**INSPECTION OF HABIB RAHMAN SECONDARY SCHOOL
CONSTRUCTION PROJECT IN KAPISA PROVINCE:
DESIGN AND SAFETY ISSUES REQUIRE ATTENTION**

October 26, 2009

SUBJECT: SIGAR Inspection Report 10-3: Inspection of Habib Rahman Secondary School
Construction Project in Kapisa Province: Design and Safety Issues Require Attention

Figure 2: Design Plan for the Habib Rahman Secondary School which builds around a previously built, unfinished structure (shaded in yellow) rather than demolishing it. (Illustration provided by Kapisa PRT)

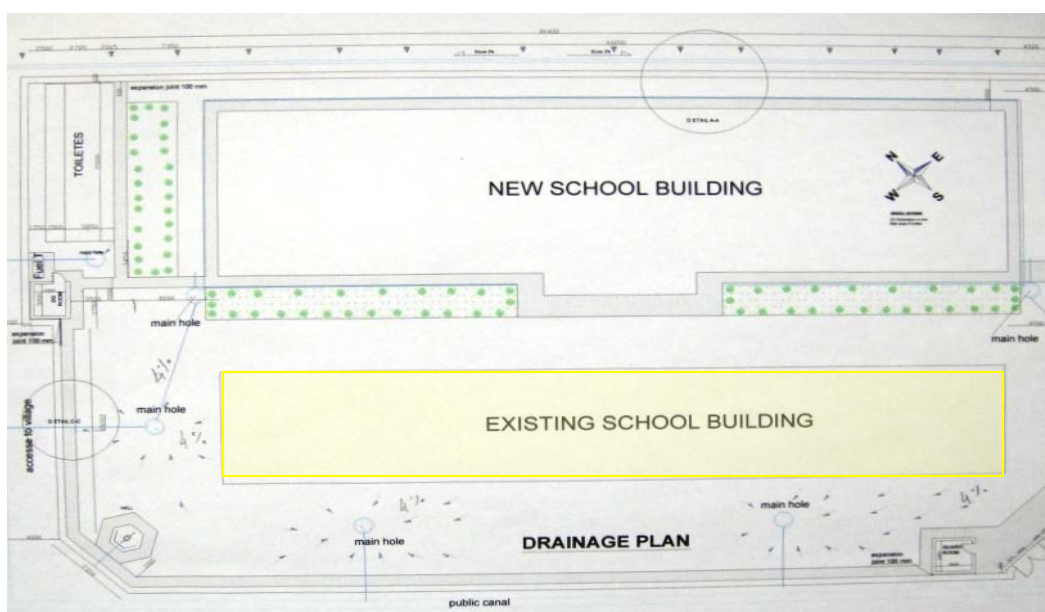
- Unfinished work left over from earlier construction at the site continues to cause major design and safety issues. The contract does not require the removal of this unfinished structure and currently there are no plans to have it demolished. SIGAR believes this abandoned construction site occupies valuable space which could be used for a number of other purposes. Additionally, it presents an unsafe environment for school children.

The first design flaw in the project noted by SIGAR focuses on the existence of a previously constructed but unfinished and unsafe structure (see Site Photo 2 and Figure 2) which occupies valuable land that could be used for a number of other purposes.³ When the Kapisa PRT became involved in the school project in the summer of 2008 following discussions with the Provincial Director of Education, it was decided that the existing structure should not be used because of concerns regarding its structural soundness. The current contract did not require the removal of this prior construction and PRT officials noted that they do not have plans to remedy this problem. SIGAR could not determine why this unfinished and unsafe structure was not demolished as part of the initial project proposal except for statements from the current PRT staff which indicated that local authorities believed they could make use of the unfinished structure. Despite attempts to

RECOMMENDATION 1: SIGAR recommends that the Commander, U.S. Forces-Afghanistan and Commander, Kapisa PRT initiate a follow-on CERP project to correct the design deficiencies noted in this report to include demolishing the previously built but unusable structure on the school compound, and constructing a protective retaining wall at the rear of the new school in place of the perimeter wall. (page 6 of SIGAR report)

KP PRT RESPONSE: Kapisa PRT partially concurs with information provided in this SIGAR Report. A follow-on project should be implemented for correcting the rear security wall and potentially adding a retaining wall and proper drainage. The reinforced concrete frame of the previously built school was left on site at the request of Nijrab government officials and local shura leaders. The engineers of the area are working to get funding to build a small community center and/or library on the site that may use some of the existing structure.
